FINAL SAFETY ANALYSIS REPORT REVISIONS  
HOPE CREEK GENERATING STATION  
DOCKET NO. 50-354

Public Service Electric and Gas Company (PSE&G) hereby submits various revisions to the Hope Creek Generating Station (HCGS) Final Safety Analysis Report (FSAR). The attached revisions to the HCGS FSAR contain: 1) text changes due to the resolution of various Safety Evaluation Report (SER) Outstanding and Confirmatory Items; 2) revisions to maintain FSAR consistency with the Technical Specifications; 3) revisions to reconcile as-built plant discrepancies; and 4) general changes to the FSAR text, tables and figures.

Attachment 1 provides a brief summary and explanation for each change while Attachment 2 contains the actual marked-up sections of the FSAR. These revisions will be incorporated in FSAR Amendment 15 after fuel load but are being filed now in order to accurately reflect the design and operation of HCGS and support the issuance of an operating license. In addition, an affidavit is provided to affirm that the matters set forth in this transmittal are true and accurate.

### SUMMARY OF CHANGES, ADDITIONS AND/OR MODIFICATIONS

FIGURE 6-2-28  
SHEET 2 OF 48

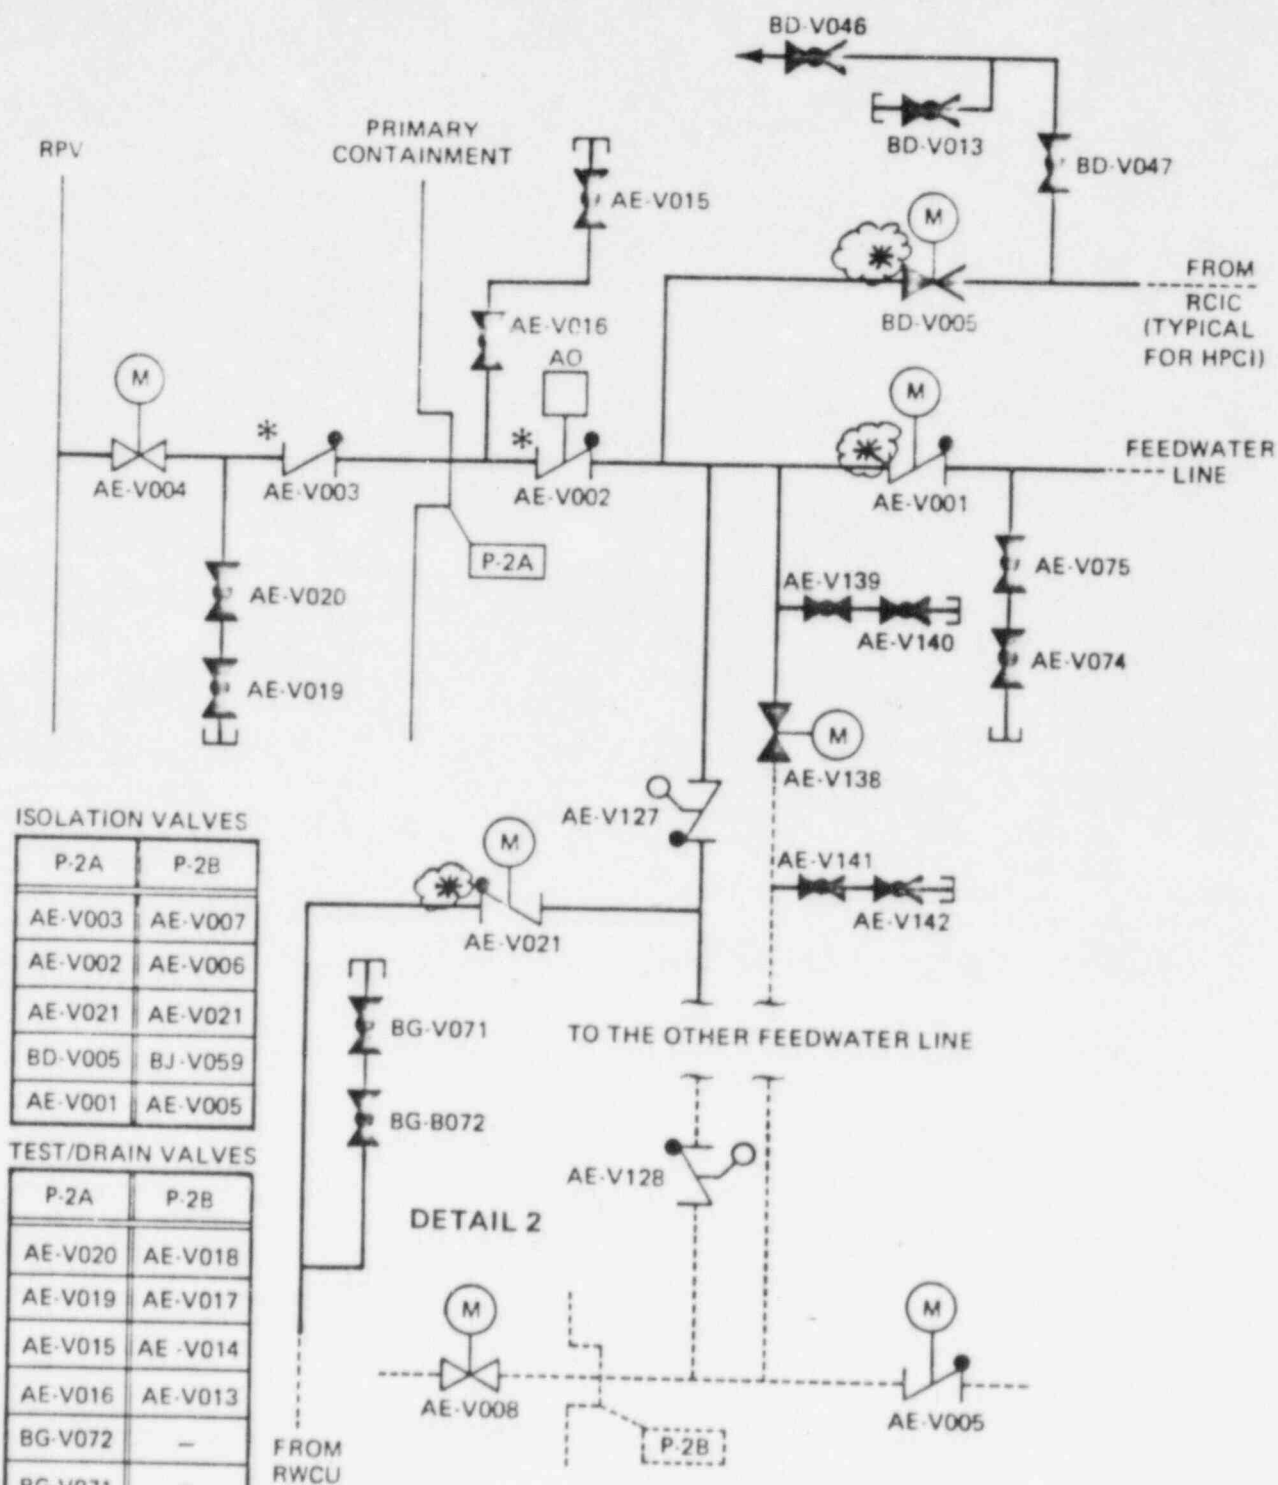
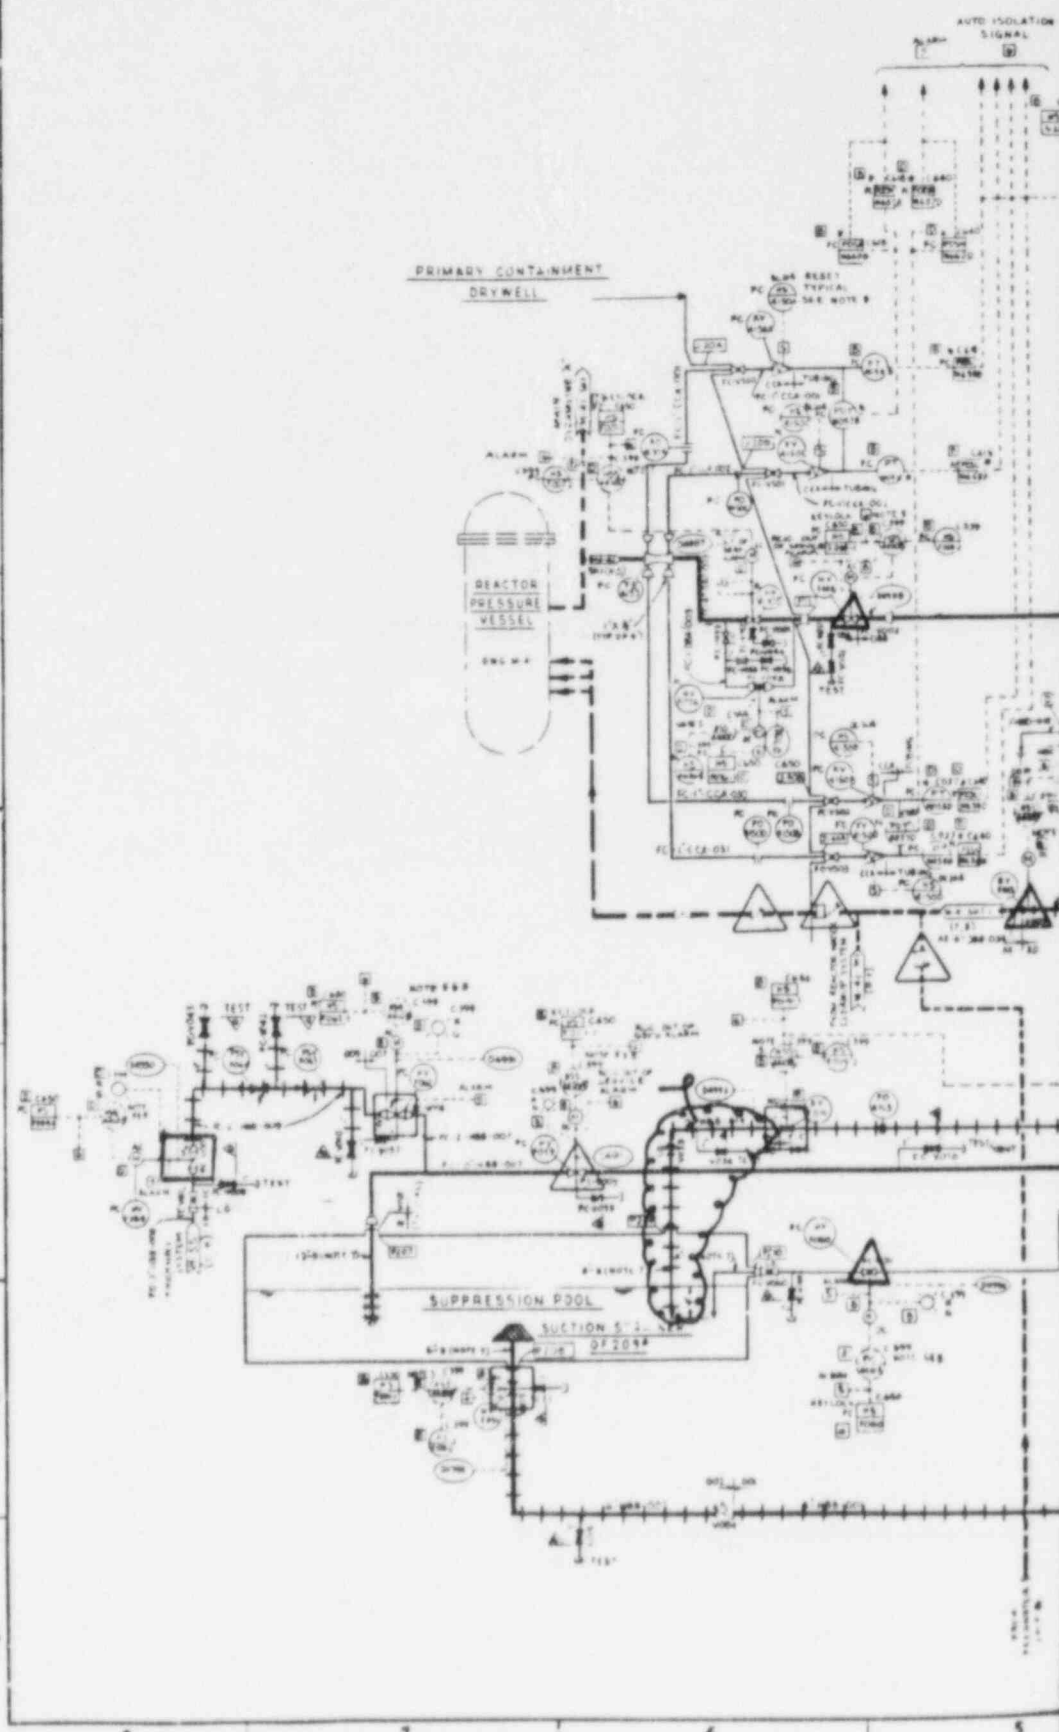
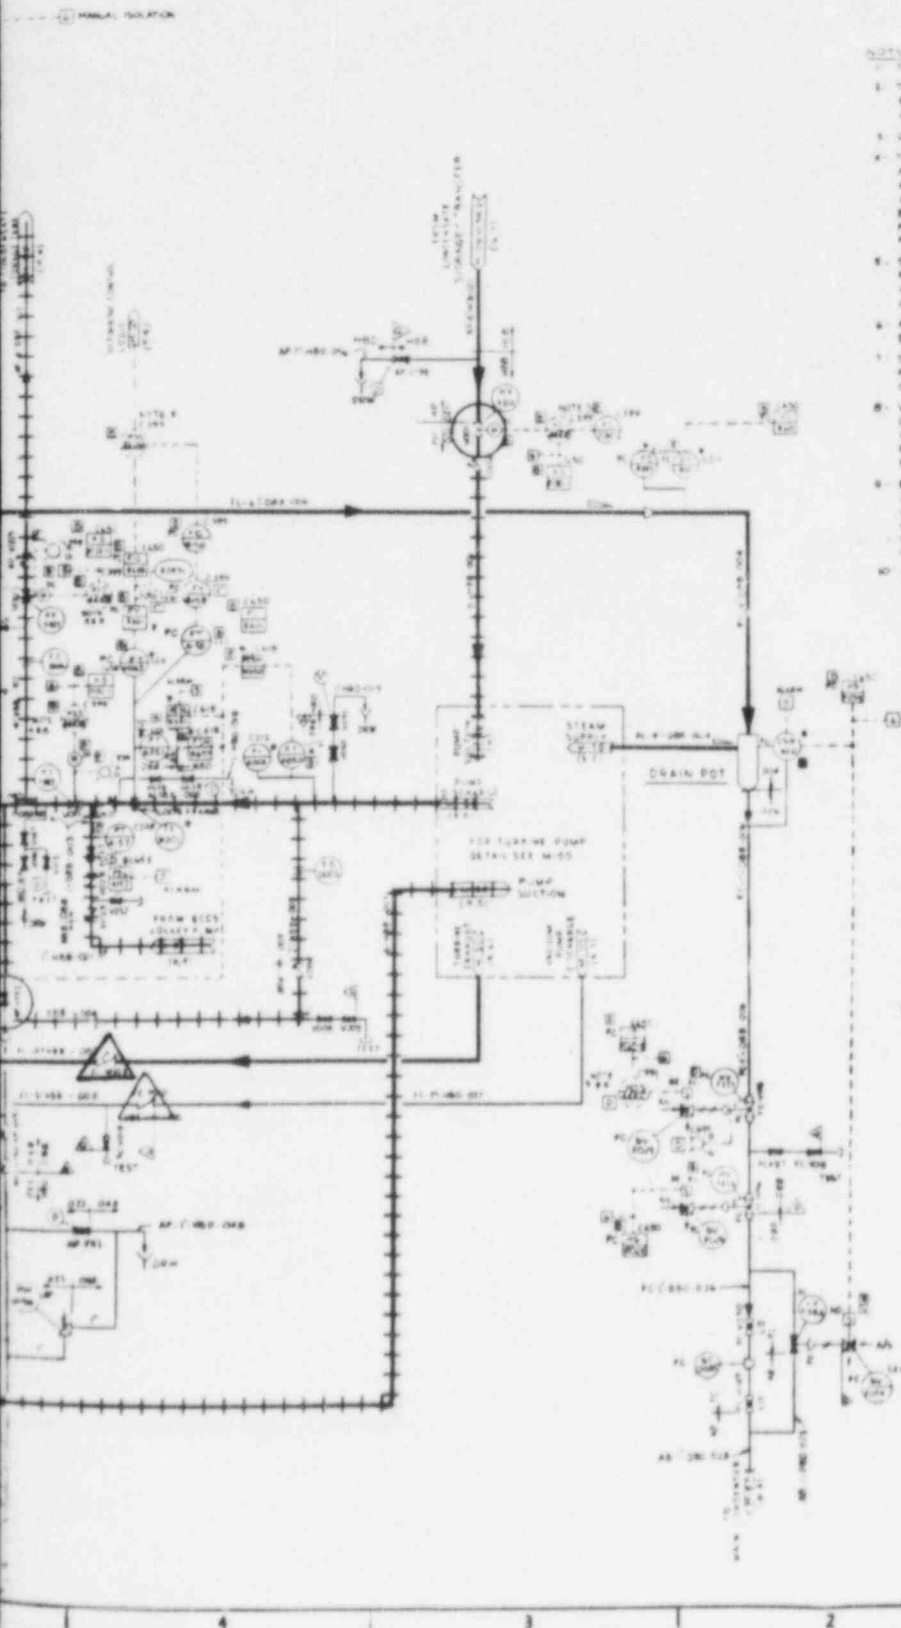
6.2.4.3.1.2      + 6.2.4.4.3 6.2.6.3 T6.2-16, pg. 1,33/33 T6.2-24, pg. 1/17 F6.2-28, sh. 2/48	Revisions clarify the feedwater line classification and testing as a result of the withdrawal of Appendix J Exemption Request #4. These revisions were previously submitted by C.A. McNeill to E. Adensam on March 11, 1986.

4 6.2-28, Sheet 2 of 48). In addition, a feedwater line fill  
4 network outside containment is used to maintain a water seal in  
4 the feedwater lines following a LOCA. The fill network consists  
4 of the HPCI and the RCIC jockey pump loops and utilizes the HPCI  
4 and RCIC injection lines to the feedwater piping to provide  
4 makeup water to the piping between the outboard check valves.~~

FIGURE 9.3-9

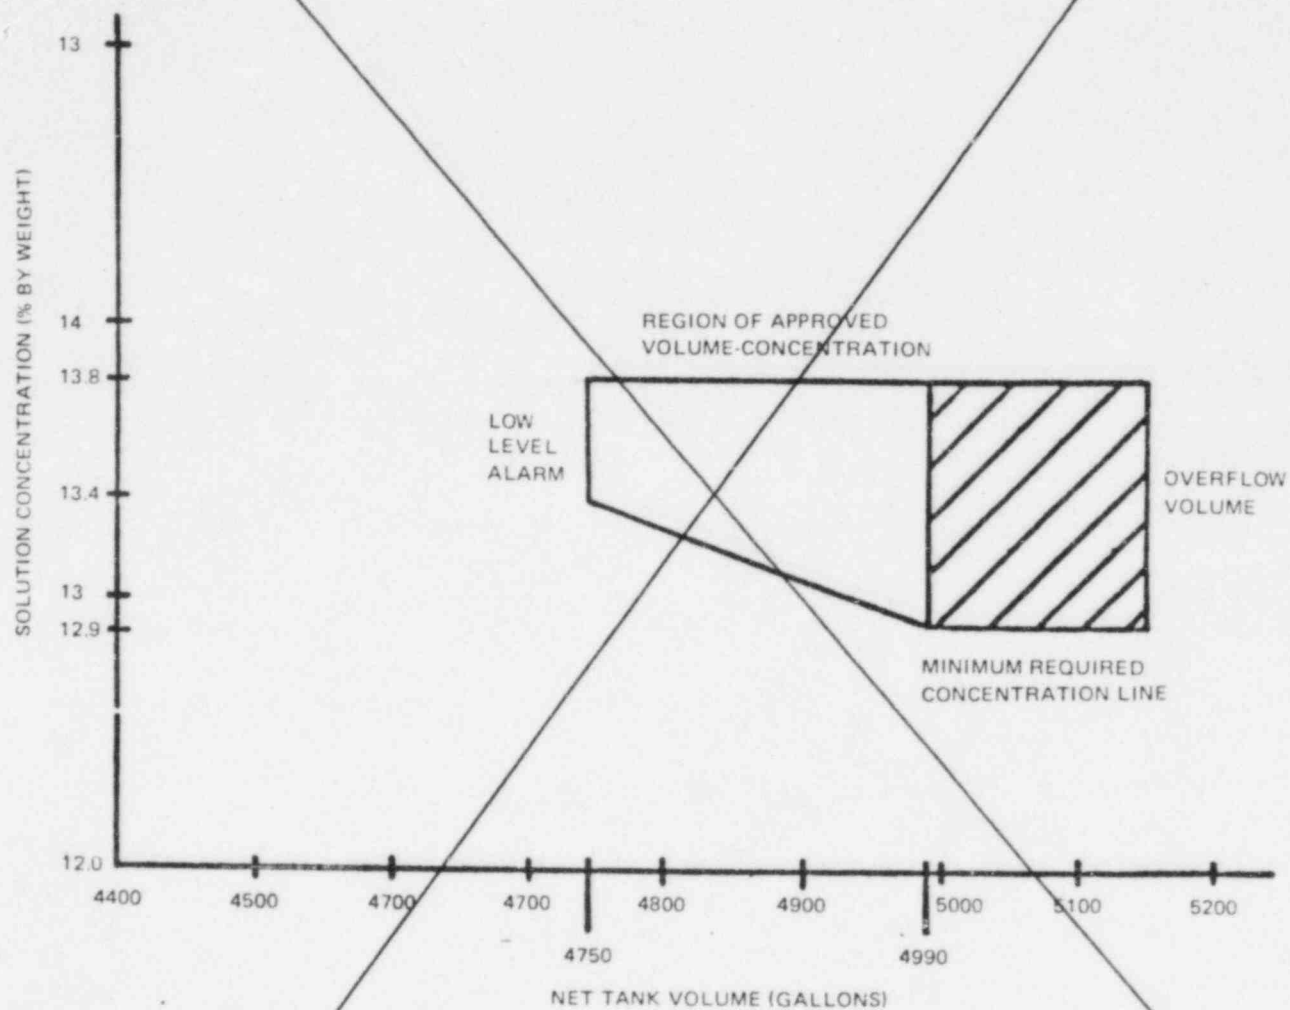
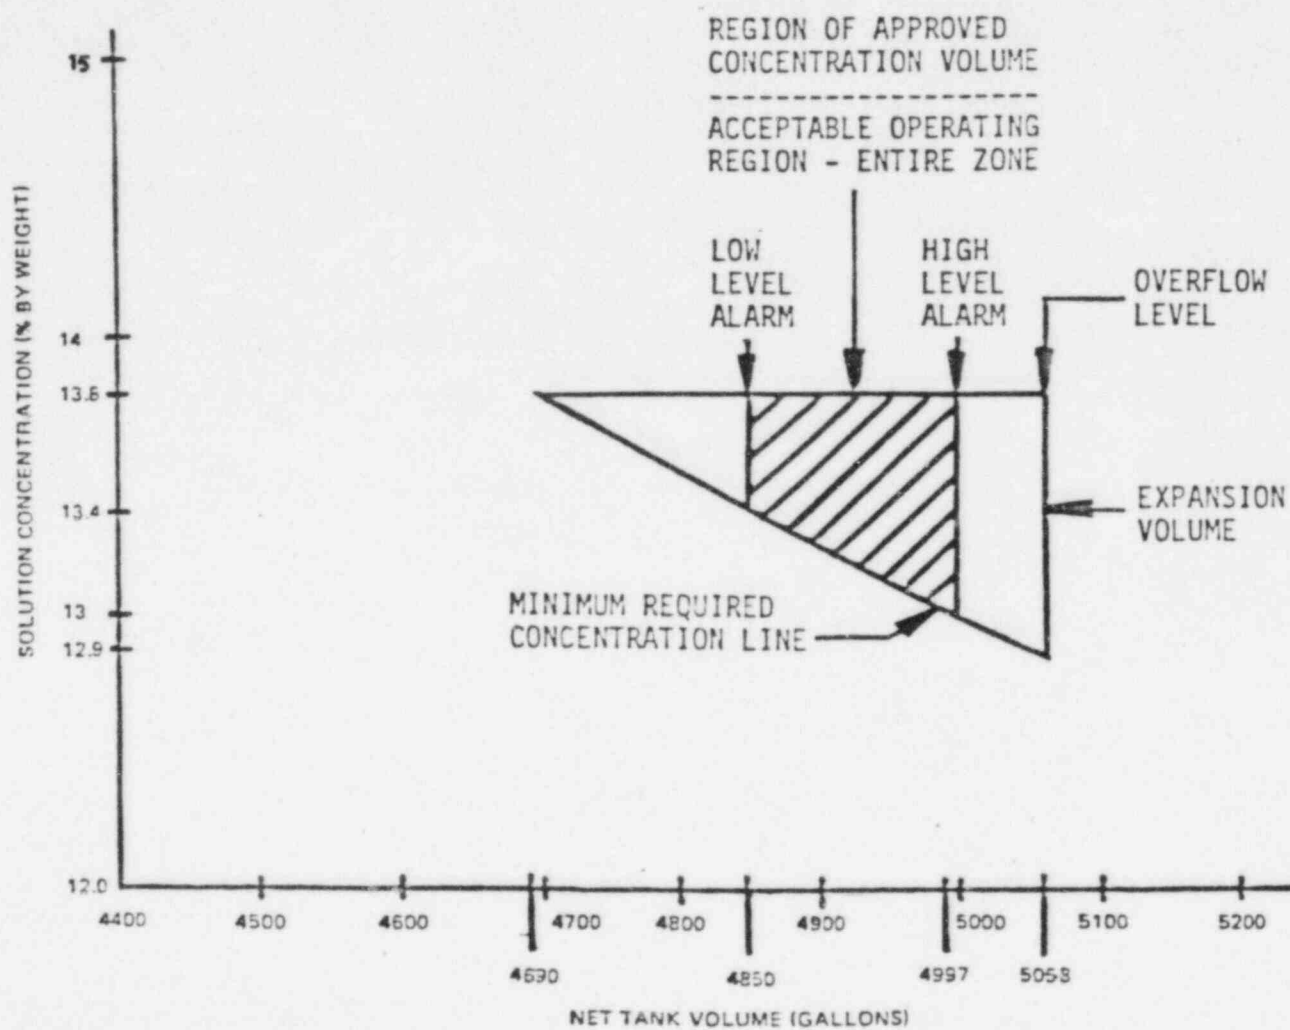
- F9.3-9 Revision provides a new figure which shows the sodium pentaborate volume concentration requirements and is consistent with Technical Specification Surveillance 4.1.5.b and Figure 3.1.5-1.

DELETE AND REPLACE  
WITH THE FOLLOWING

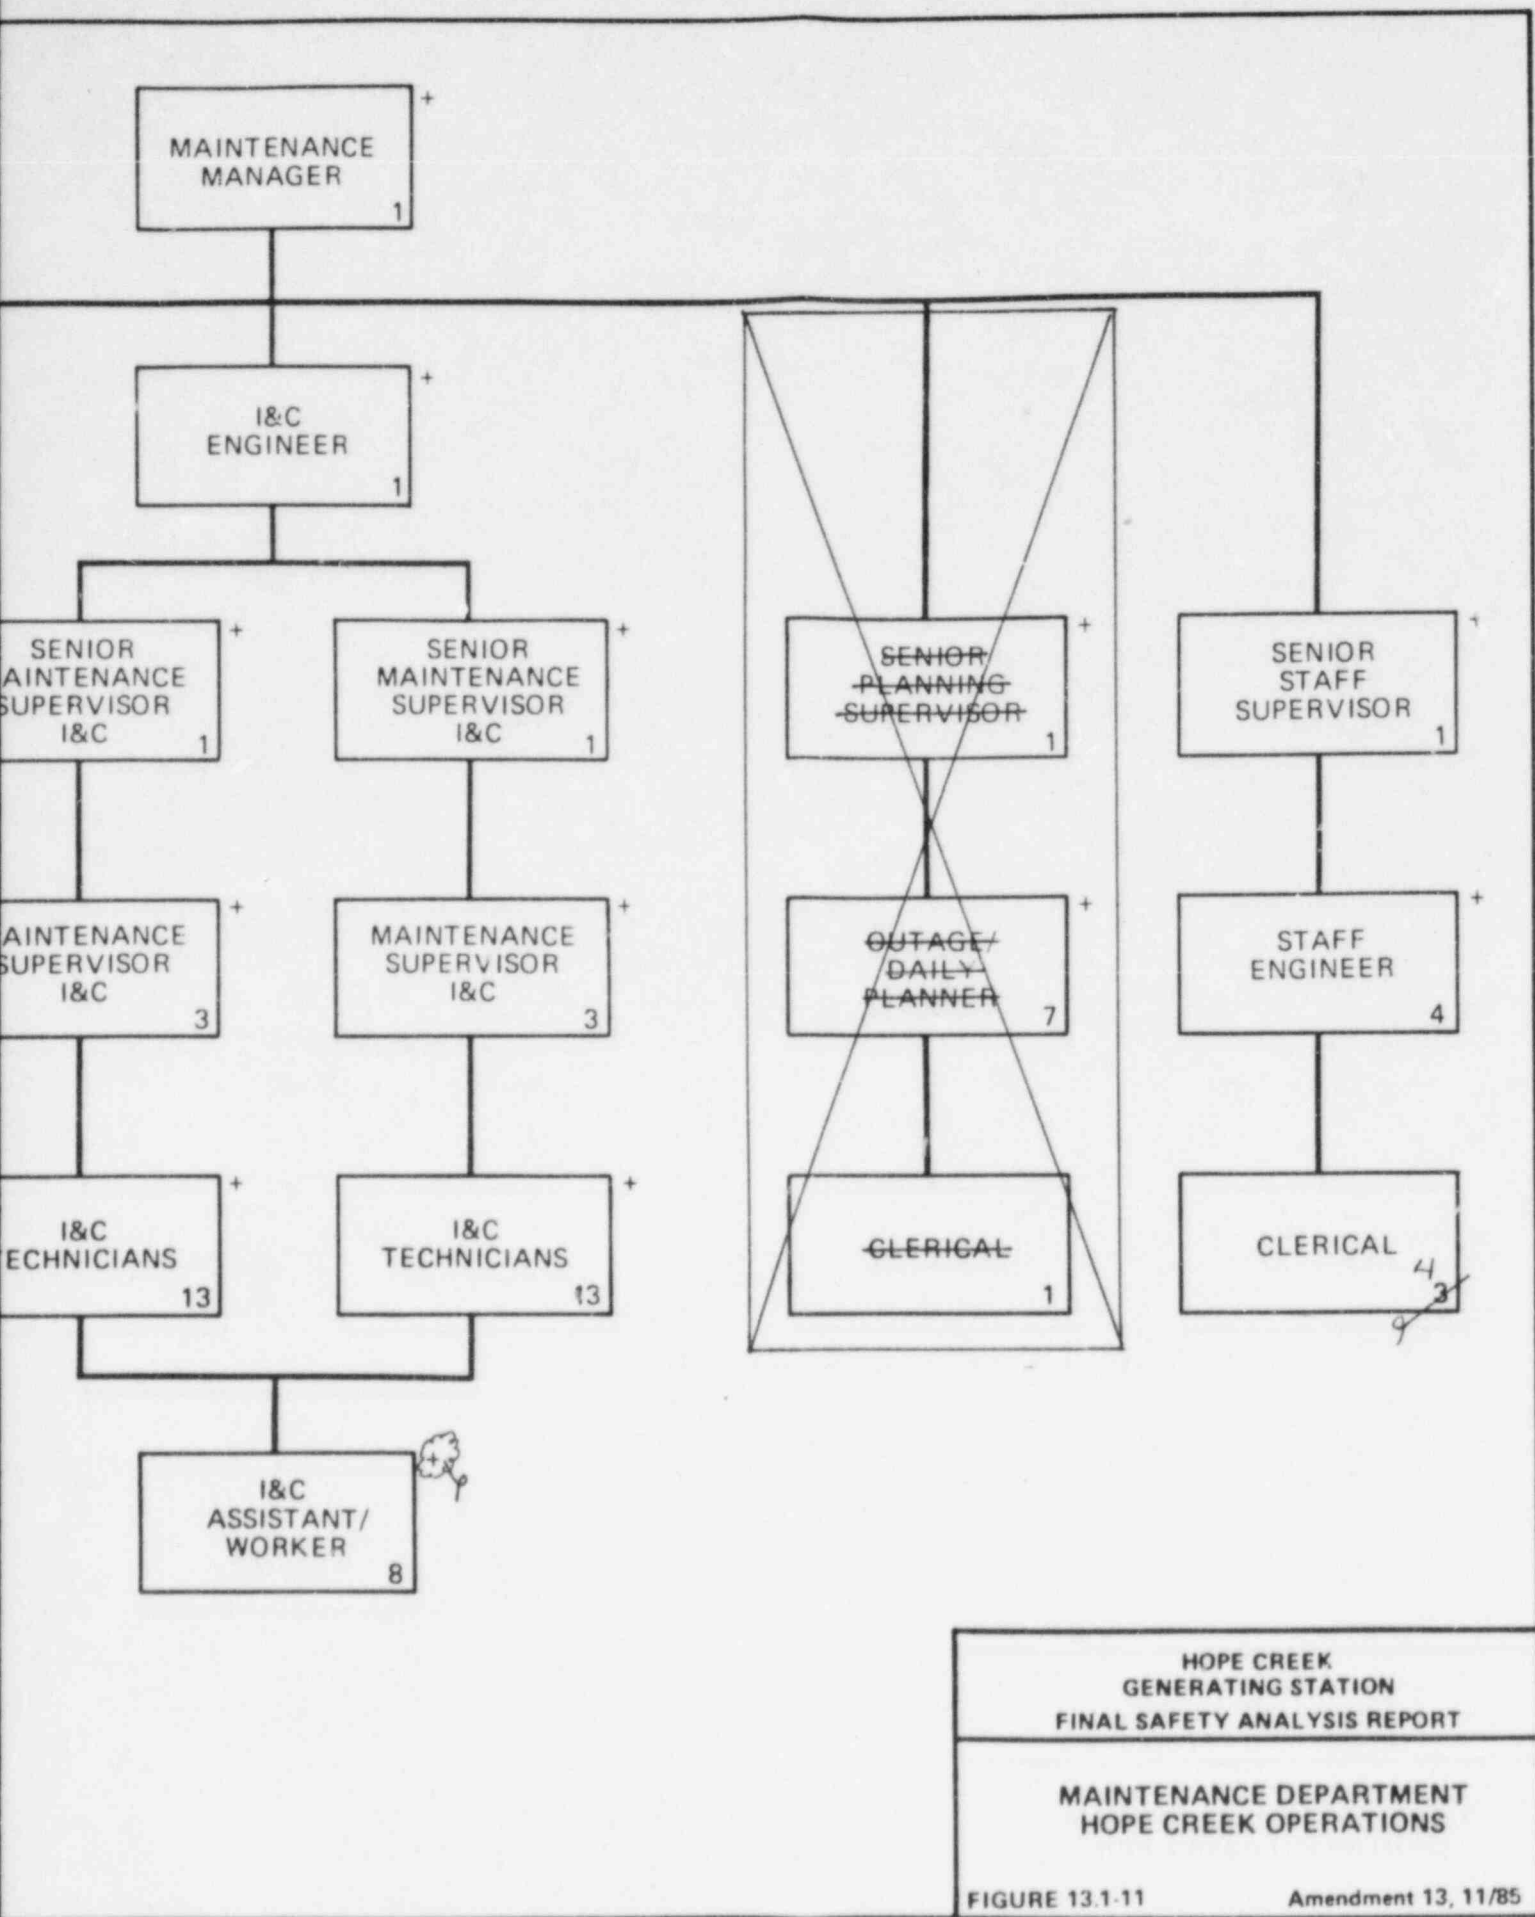
- 13.1.2.2.8.e \*  
F13.1-11 Revisions reflect a recent maintenance department reorganization which impacts summary statements made in SER Section 13.1.2.1(3), page 13-7, of Supplement 5.

- 13.1.3.1  
T13.1-3,  
pg. 2/3  
F13.1-11  
13.2.1.1.1 Revisions necessary to reflect ANSI/ANS-3.1 manning criteria and implements various training requirements.
